SEWAGE DISPOSAL SYSTEM

HOWARD COUNTY HEALTH DEPARTMENT

SUBDIVISION Forsythe Estates (Dye) LOT 1 ROAD 14500 Monticello Avenue

RE: **Building Permit # B15002484**
14275 Old Frederick Road
Cocksville, Maryland 21723

INDICATE NORTH - NAME ADJOINING ROADWAY AS BASE LINE

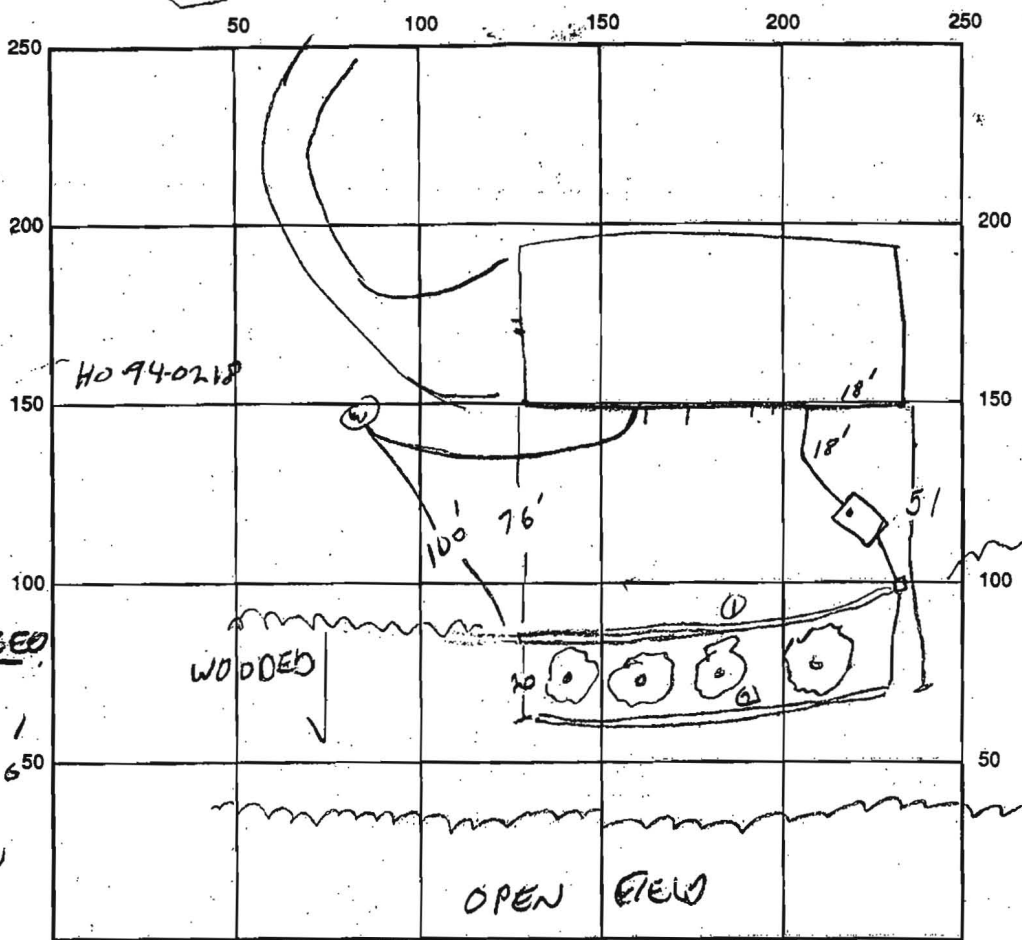
W.P.I.
 4-8-96
 OK *sf*
 NOTE:
 SEALED
 WELL CAP
 TO BE INSTALLED
 CALL
 BULLYER *sf*
 DISCUSSED WITH
 RICHARD HUDSON
 (OWNER) 4-8-96
sf

SEPTIC TANK LEVEL OK CLEANOUTS LOW TANK
 DISTRIBUTION BOX LEVEL OK
 DRAIN FIELD/TITLE DEPTH 7 FT. TRENCH WIDTH 2 FT. INLET DEPTH 3 FT.
 EFFECTIVE GRAVEL DEPTH 4 FT. TOTAL LENGTH $\frac{1}{2} \times 80 = 160'$ FT.
 NUMBER OF TRENCHES 2 ONE SIDEWALL/BOTTOM AREA 640 SQ. FT.
 DRYWALL INSIDE DIAMETER — FT. EFFECTIVE DEPTH BELOW INLET — FT.
 ABSORBENT AREA — SQ. FT.

REMARKS: OK TO COVER SYSTEM - WALL CONNECTION NOT MADE YET.
4/8/96 - HOUSE CONNECTION OK

WALK-THRU BUILDING PERMIT
BP# B15002484A#

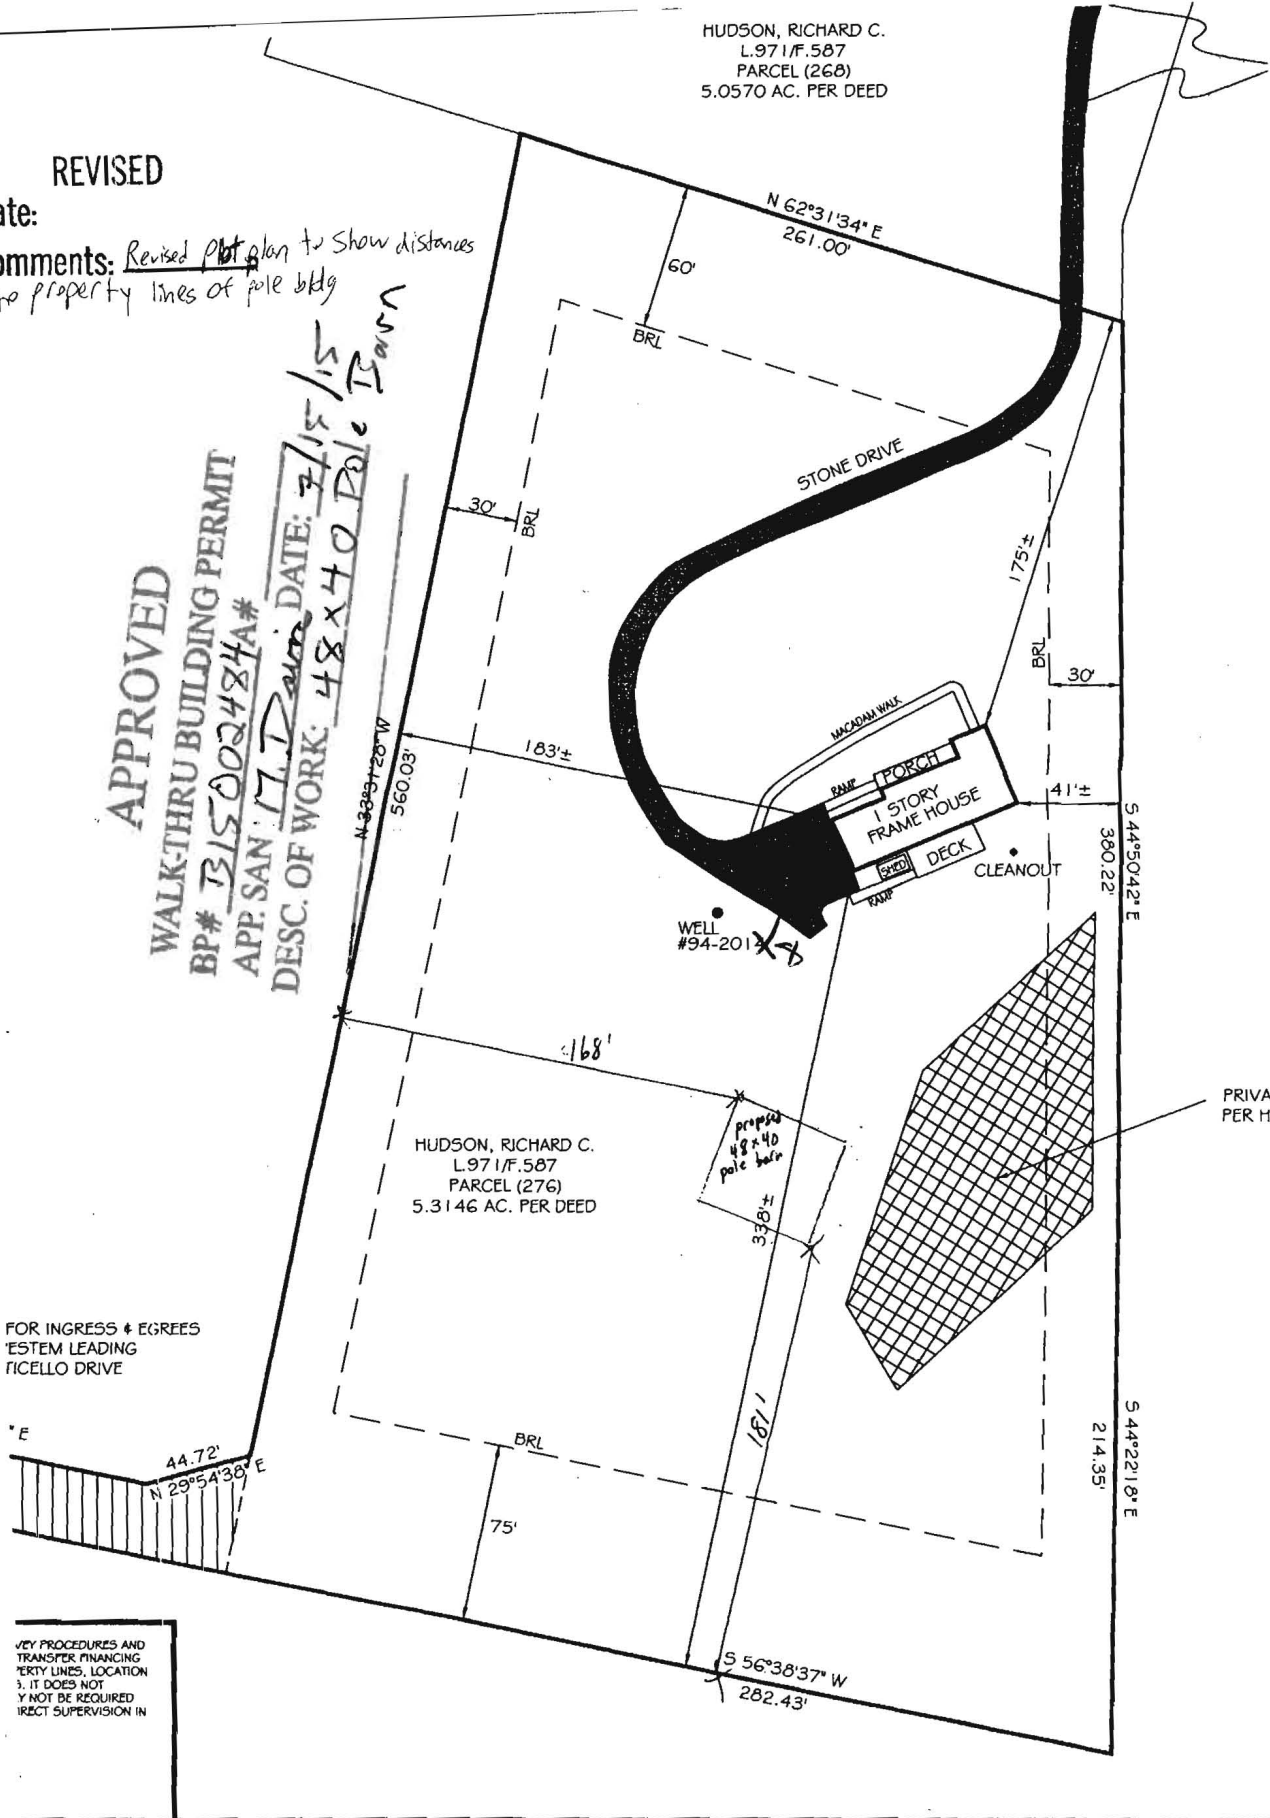
Comments: Revised ~~plot~~ plan to show distances to property lines of pole bldg

7-14-15 Site Visit conducted on 7-14-15. No signs of failure. Well tag number is recorded on proposed plan incorrectly. H0942018 is the correct well tag #.

Area needed for pole barn is in the well radius for the septic setback and cannot be used for septic area.
